# UNITED STATES PATENT AND TRADEMARK OFFICE

APPLICATION NO.	FILING DATE	FIRST NAMED INVENTOR	ATTORNEY DOCKET NO.	CONFIRMATION NO.
10/768,095	02/02/2004	Francois Houde	12214-3US	5766
20988	7590	05/23/2006	EXAMINER	
OGILVY RENAULT LLP 1981 MCGILL COLLEGE AVENUE SUITE 1600 MONTREAL, QC H3A2Y3 CANADA			BANKHEAD, GENE LOUIS	
			ART UNIT	PAPER NUMBER
			3744	
DATE MAILED: 05/23/2006

<b>Office Action Summary</b>	Application No. 10/768,095	Applicant(s) HOUDE, FRANCOIS	
	Examiner Gene L. Bankhead	Art Unit 3744

Figure 3 (Noba)

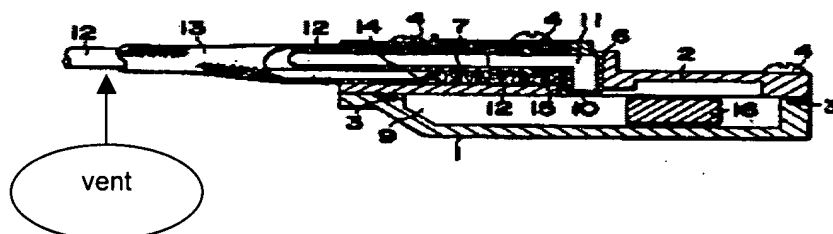
Claim 6 is rejected under 35 U.S.C. 103(a) as being unpatentable over Aston in view of Noba (US 3944774). Claim 6 differs from Aston in calling for a vent in the electric relay capable of venting ionized air. Noba discloses an electric relay with a casing 1, and a vent 12 capable of venting ionized air produced during the relays operation, see Figure 3 below. Noba teaches it is advantageous to be able to conduct air into and from a casing surrounded by insulation. It would have been obvious to one of ordinary skill in the art at the time of the invention provide the thermostat electric relay of Aston with a vent in view of Noba in order to prevent overheating of the relay.

Claim 15 is rejected under 35 U.S.C. 103(a) as being unpatentable over Aston in view of Noba. Aston discloses all limitations of claim 11, however does not disclose a vent for the second casing housing the electric relay. Noba discloses an electric relay with a casing 1, and a vent 12 capable of venting ionized air produced during the relays operation, see Figure 3 above. Noba teaches it is advantageous to be able to conduct air into and from a casing surrounded by insulation. It would have been obvious to one of ordinary skill in the art at the time of the invention provide the thermostat electric relay of Aston with a vent in view of Noba in order to prevent overheating of the relay.

Figure 4 (Nesbitt)

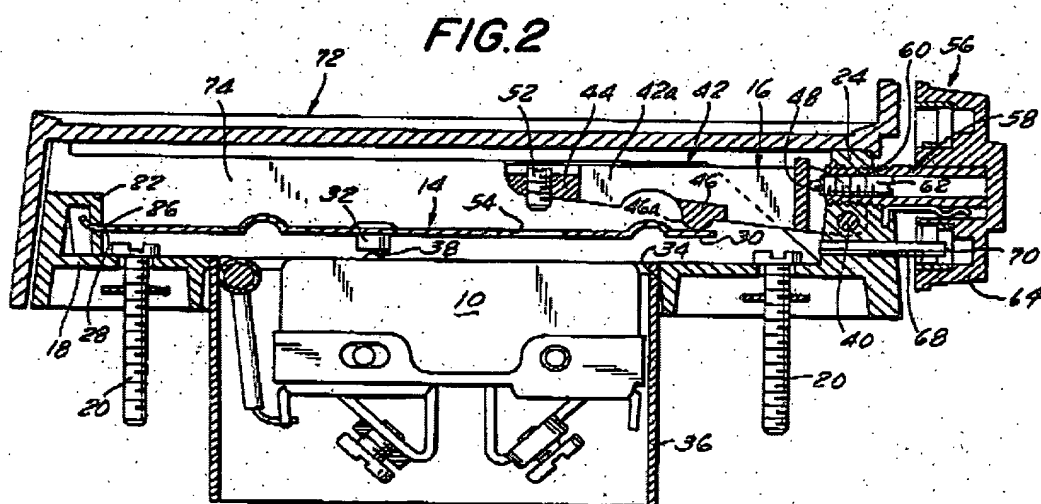
Claims 7-10 are rejected under 35 U.S.C. 103(a) as being unpatentable over Aston in view of Nesbitt (US 6347747) in further view of Noba and Moyer et. al (US 3421131), as applied to claim 6 above. Claim 7 differs from Aston in calling for a male projection received in a corresponding female part to extend axially through a primary casing with a pathway for air from the electric relay to flow. Moyer discloses a thermostat assembly wherein a male projection 20 is received in a corresponding female part 18, with a gasket about the male projection 26 to tighten the base plate 18 and cover 72, see Figure 5 below. Claim 10 differs from Aston in calling for a primary casing with at least one opening for pouring insulation material into the chamber of the thermostat. Nesbitt teaches a casing 1, see Figure 4 below, with vents capable of venting ionized air from the electric relay, and for pouring insulation material into the chamber of the thermostat. Nesbitt teaches it is advantageous for air to flow directly across the temperature sensor surface of thermostat. Therefore it would have been obvious to one of ordinary skill in the art at the time of the invention to modify Aston with Nesbitt, Moyer and Noba in order for the outside ambient air temperature to be detected with greater precision and speed, and to ensure a more rigid connection between the circuit board and base plate, firmly securing the electronic components in the event of mechanical damage to the thermostat.

Claim 18 is rejected under 35 U.S.C. 103(a) as being unpatentable over Aston in view of Nesbitt. Aston discloses all limitations of claim 11 however does not disclose an opening in the primary casing for pouring sound insulation material into the chamber of the thermostat. Nesbitt teaches a casing 1, see Figure 4 above, with vents for pouring insulation material into the chamber of the thermostat. Nesbitt teaches it is advantageous for air to flow directly across the temperature sensor surface of thermostat. It would have been obvious to one of ordinary skill in the art at the time of the invention to modify the thermostat of Aston with casing of Nesbitt in order for ambient air to directly reach the thermostat temperature sensors more quickly, and thus enable outside ambient air temperature to be detected with greater precision and speed
